Work Order ID 91780

Item Name: Crosstube Turning Detail

DART AEROSPACE LTD	Work Order:	91780
Description: Crosstube Assembly (412 High Aft)	Part Number:	D412-664-243
Inspection Dwg: D412-664-243 Rev: E		Page 1 of 2

DRAWING NO. D412-664-243	TITLE CROSSTUBE ASSEMBLY (412 HI AFT)	REV. E	DART AEROSPACE LTD ENGINEERING ORDER		D.E.O. NO. D412-664-243-E-1	SHEET NO. SHEET 1 OF 2	SCALE NTS
DRAWN	CHECKED	MFG. APPR.	APPROVED	DE APPR.			
DATE 11.03.31	DATE 11/03/31	DATE 11.03.31	DATE 11/03/31	DATE 11-03-31

**D412-664-243
ASSEMBLY DETAIL**

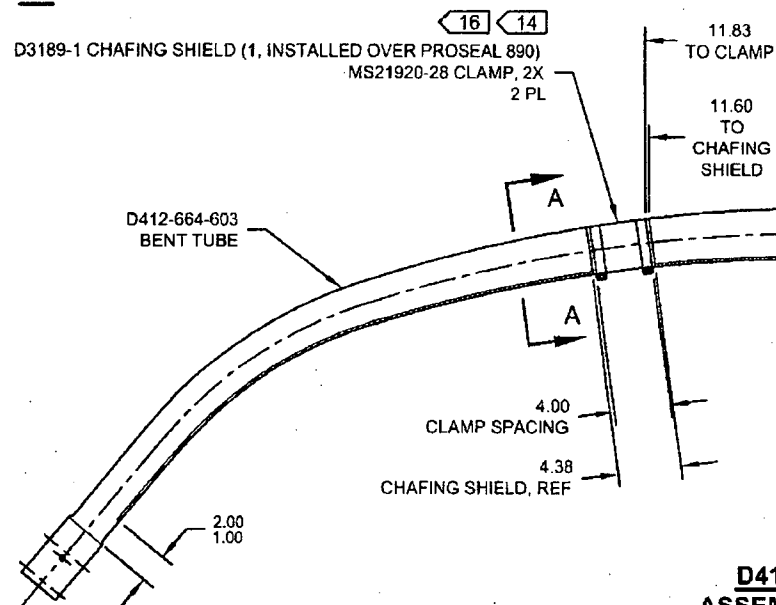
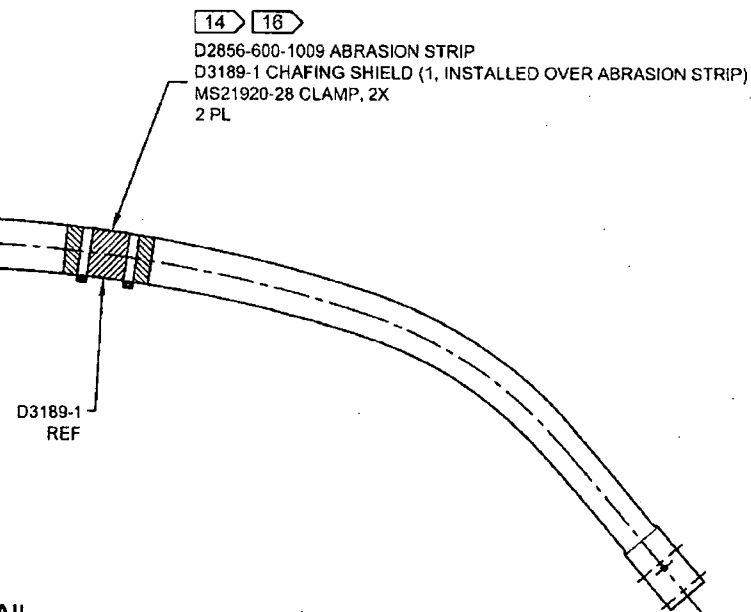
PURPOSE:

REMOVED ABRASION STRIP IN FAVOR OF A THIN LAYER OF PROSEAL 890. UPDATE INSTALLATION OF CHAFING SHIELDS AND REDUCE TORQUE TO 40-50 IN-LBS. THIS ENGINEERING ORDER SUPERCEDES DEO D412-664-243-E-1.

IS:

WAS:
